Docket Nos.: 50-269, 270, 287, 289, 302, 312, 313, 346

FACILITIES: Oconee Nuclear Station, Units No. 1, 2 & 3  
Three Mile Island Nuclear Station, Unit No. 1  
Crystal River Unit No. 3, Nuclear Generating Station  
Rancho Seco Nuclear Generating Station  
Arkansas Nuclear One, Unit No. 1  
Davis-Besse Nuclear Power Station, Unit No. 1

SUBJECT: SUMMARY OF MEETING HELD ON JULY 18, 1979 TO DISCUSS BABCOCK  
& WILCOX (B&W) SMALL BREAK LOSS-OF-COOLANT ACCIDENT (LOCA)  
ANALYSES (REACTOR COOLANT PUMPS OPERATING VERSUS TRIPPED)

CRAFT2 NODING DIAGRAM FOR SMALL BREAKS  
(6 NODE MODEL)

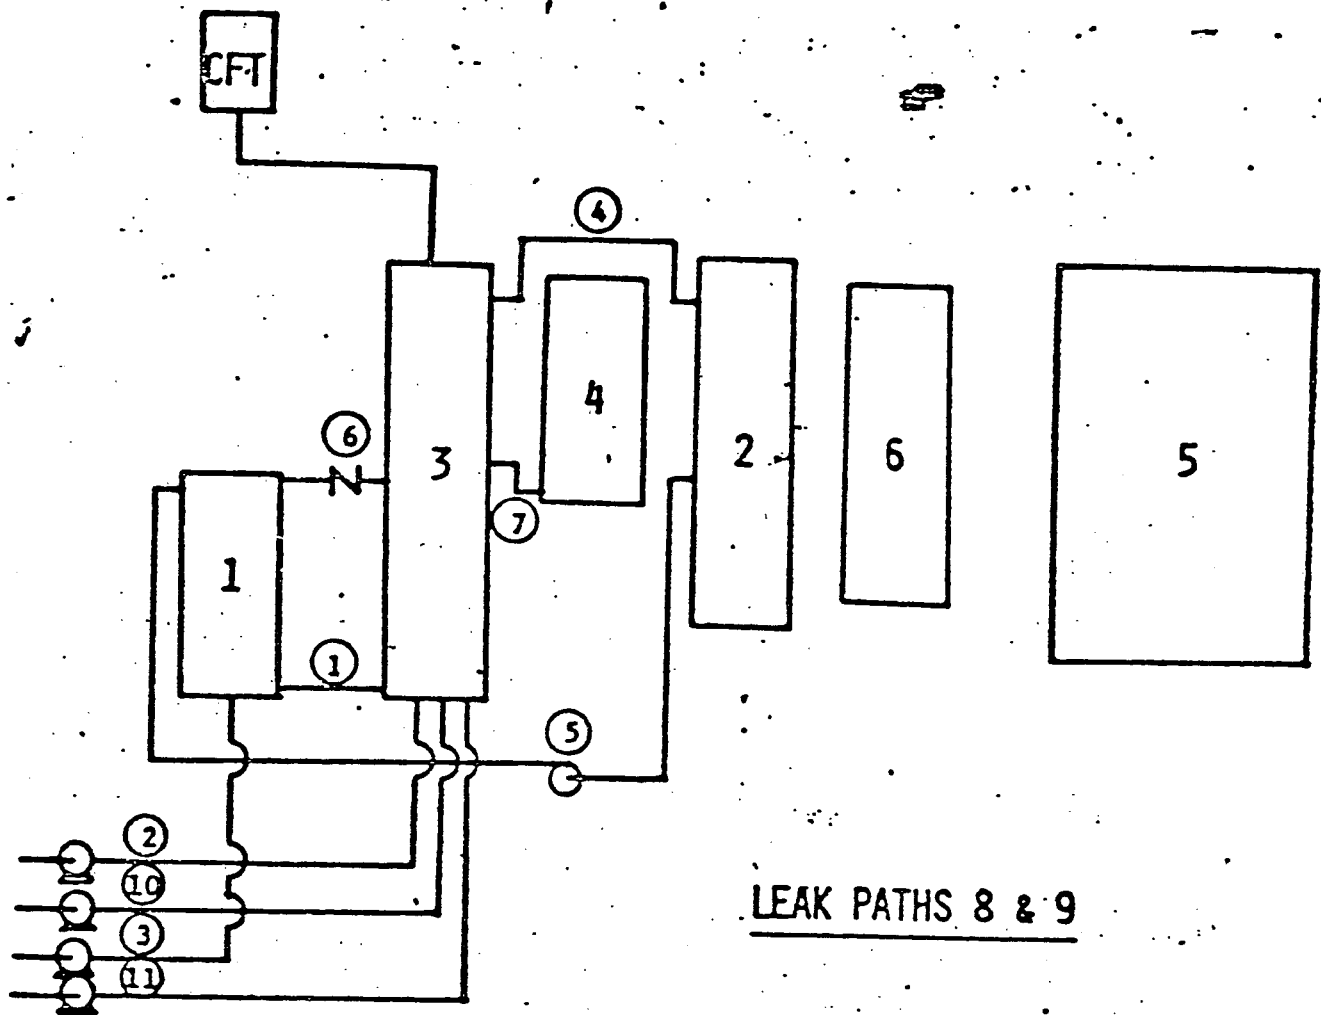
- (1) the six node CRAFT-2 model was found to produce void fractions several percent lower than the 23 node model normally used for small break analyses,
- (2) no liquid carryout was assumed to occur from the core during the reflooding period,
- (3) a homogeneous void distribution model was used in CRAFT-2 during the time the RCPs were operating. This assumption maximizes the liquid lost through the break and may be overly conservative, and
- (4) the adiabatic heat-up model used when the core is uncovered may also be overly conservative.
